**ADDENDUM NO. 1  
TO  
CONTRACT & SPECIFICATIONS  
RANGELEY LAKE STATE PARK  
BOATING FACILITY IMPROVEMENTS  
RANGELEY, MAINE  
October 18, 2024**

BOATING FACILITY IMPROVEMENTS  
RANGELEY LAKE STATE PARK

PROJECT  
**BOATING FACILITY IMPROVEMENTS**  
RANGELEY LAKE STATE PARK  
TITLE  
**PROPOSED SITE PLAN AND**  
**WATERFRONT WALKWAY PROFILE**

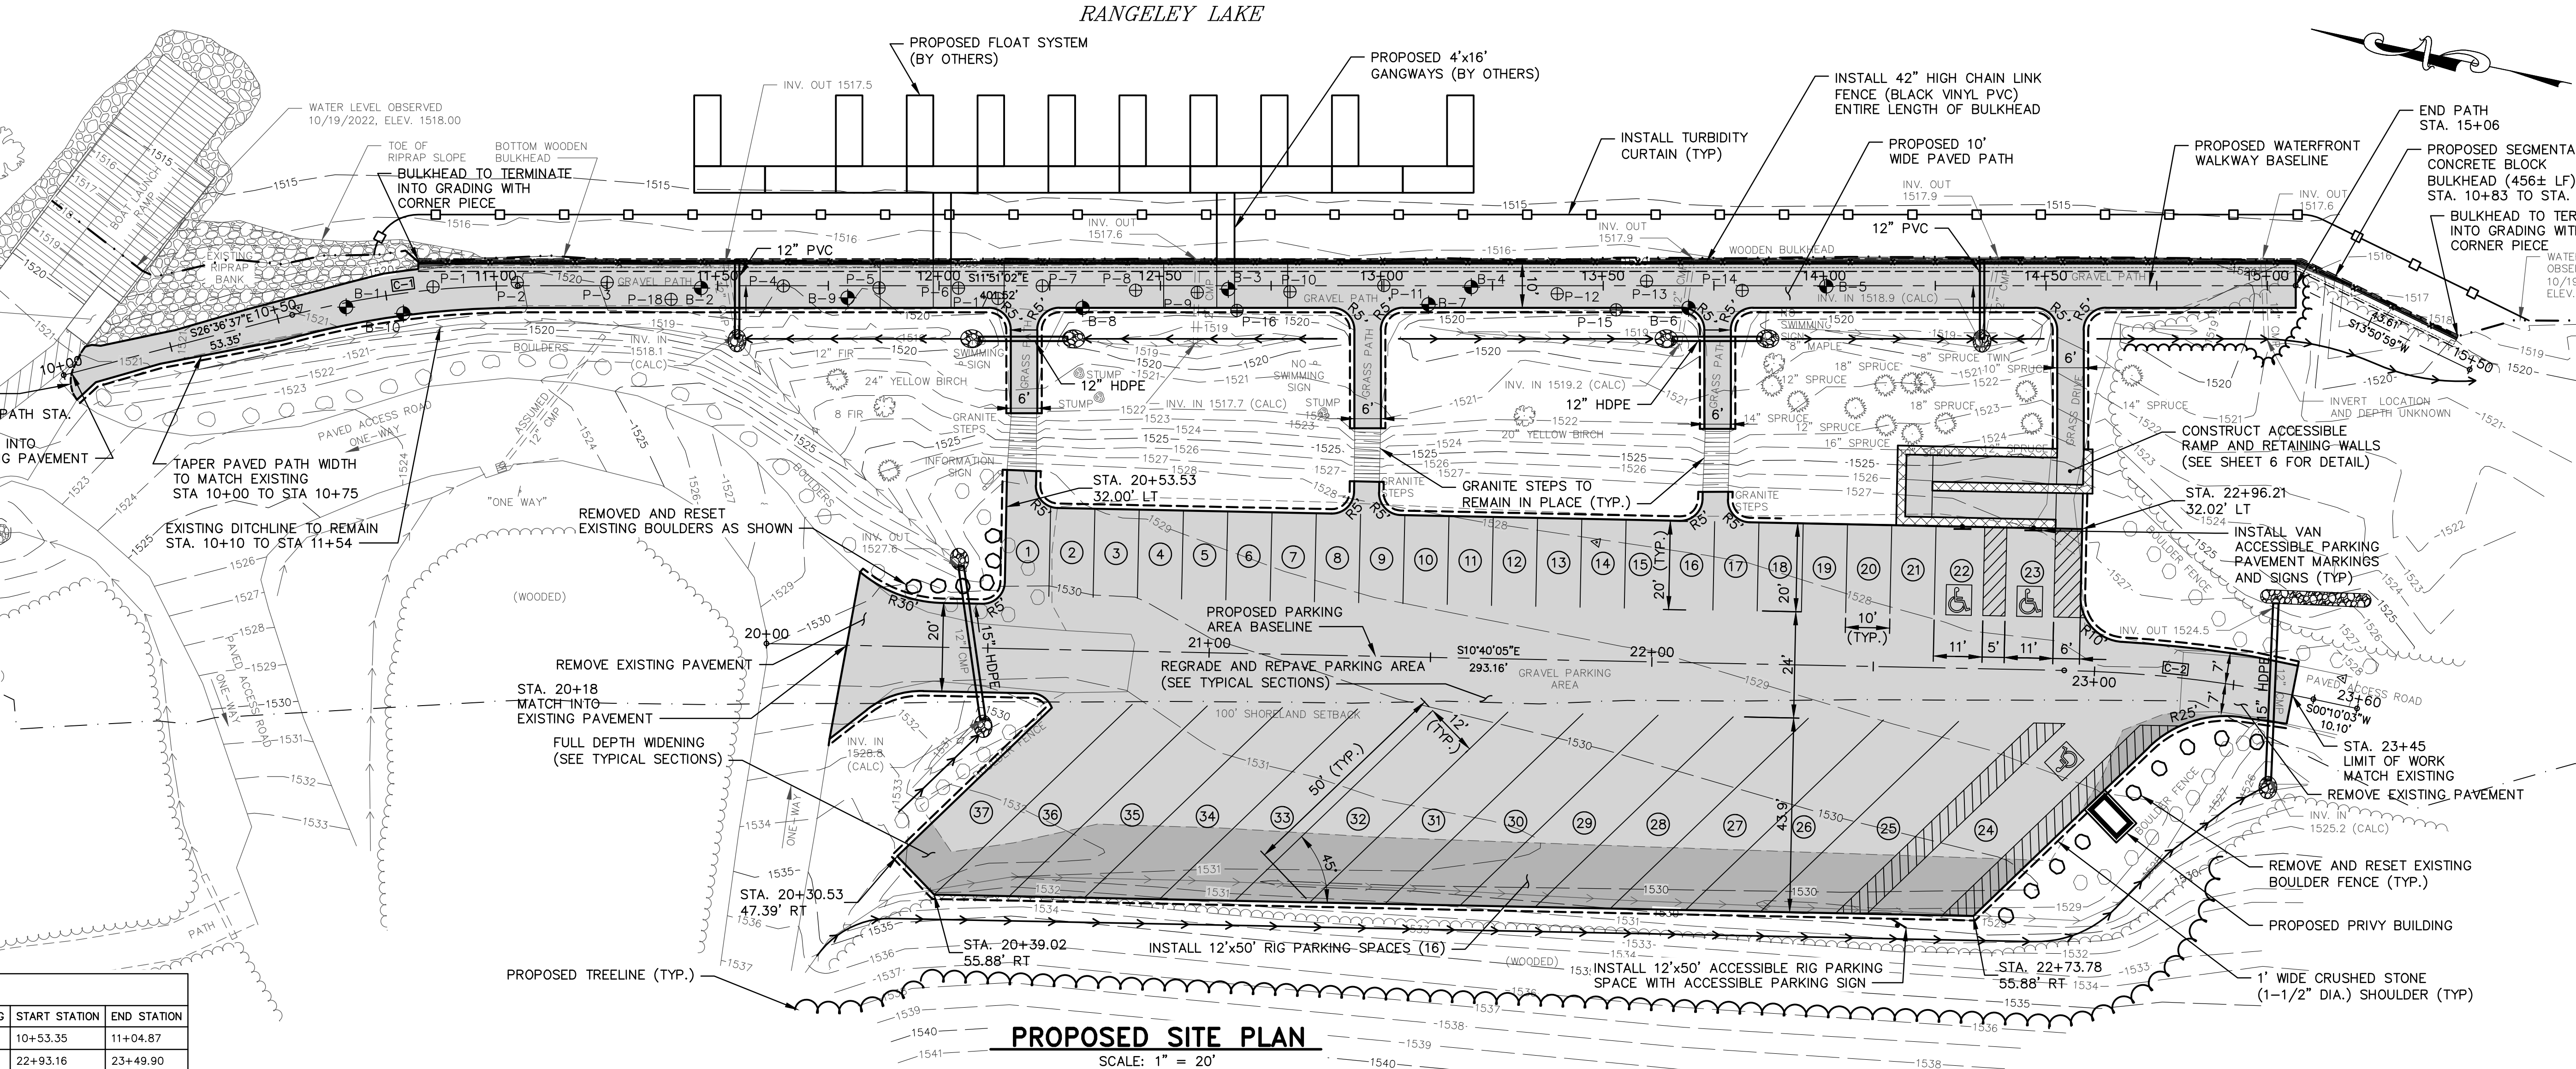
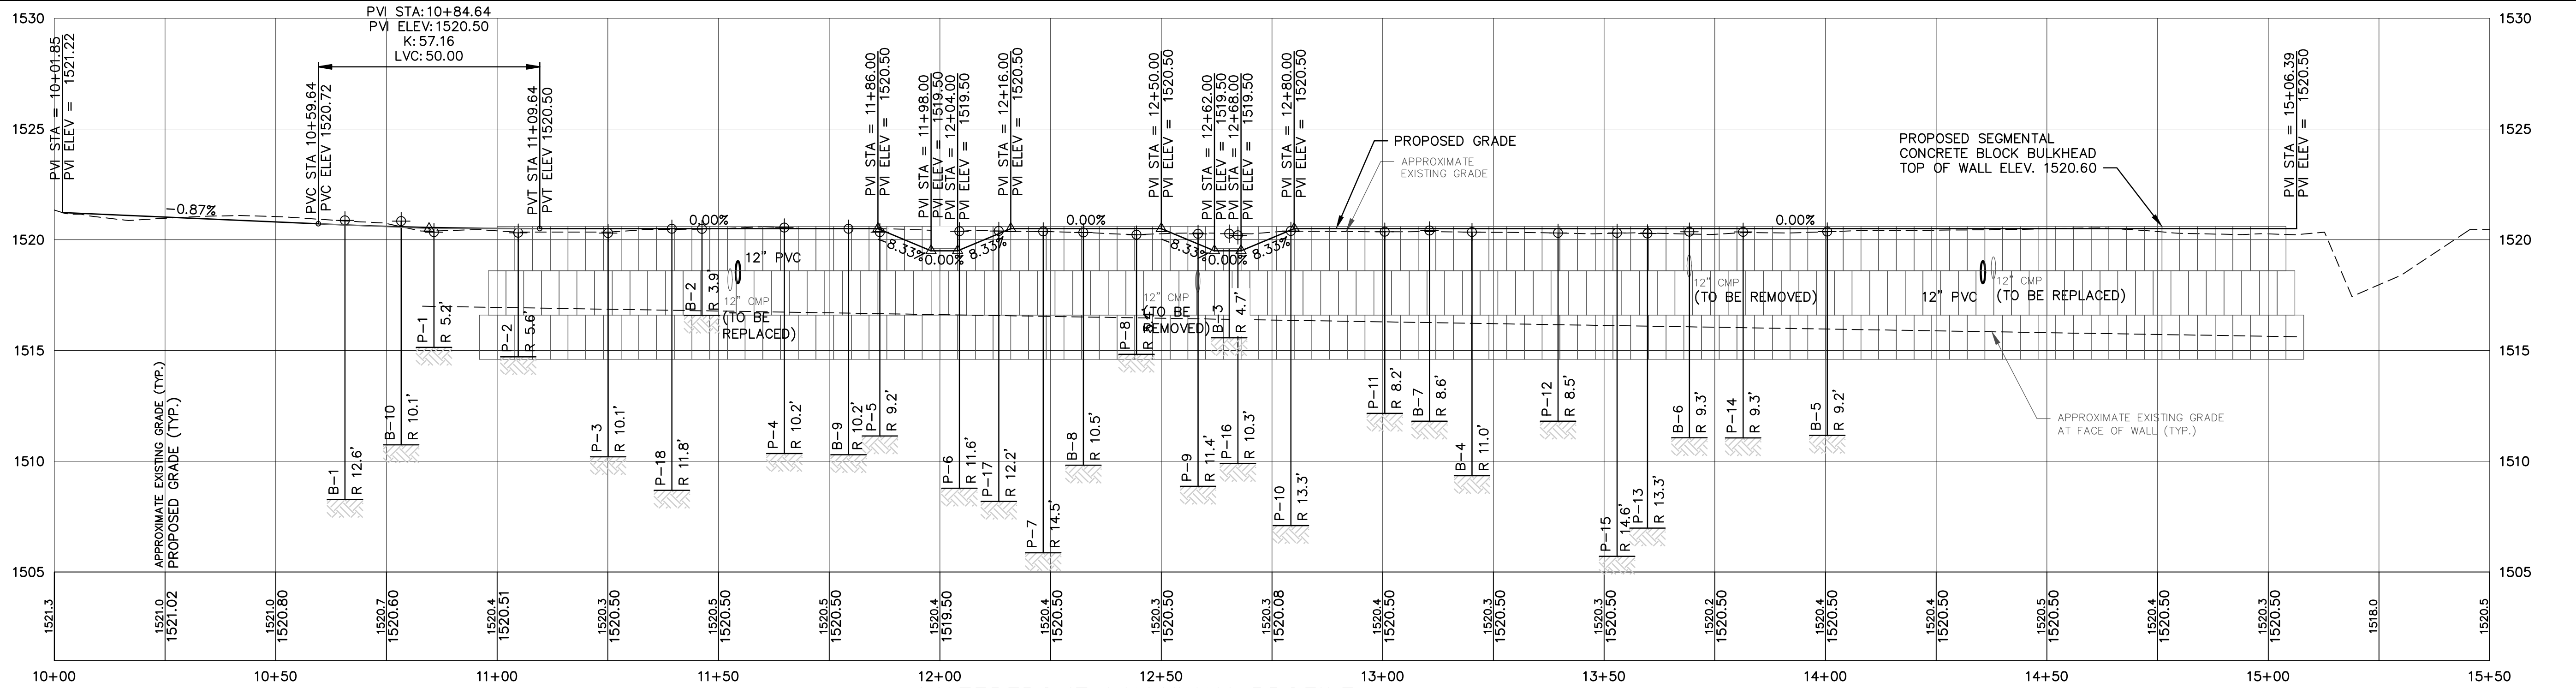
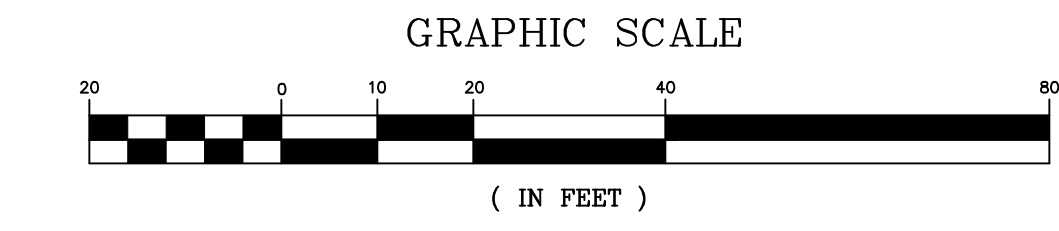
1. Added the installation of a vault privy and access way. See Sheets 4,5, & 13 of 13.
2. Added a stone level spreader at the outlet of the 15" HDPE Culvert. See Sheets 4 & 5 of 13.
3. Extended paved walkway to boat launch. Sheets 4 & 5 of 13
4. Added a cross section of the accessible ramp. See Sheet 6 of 13.
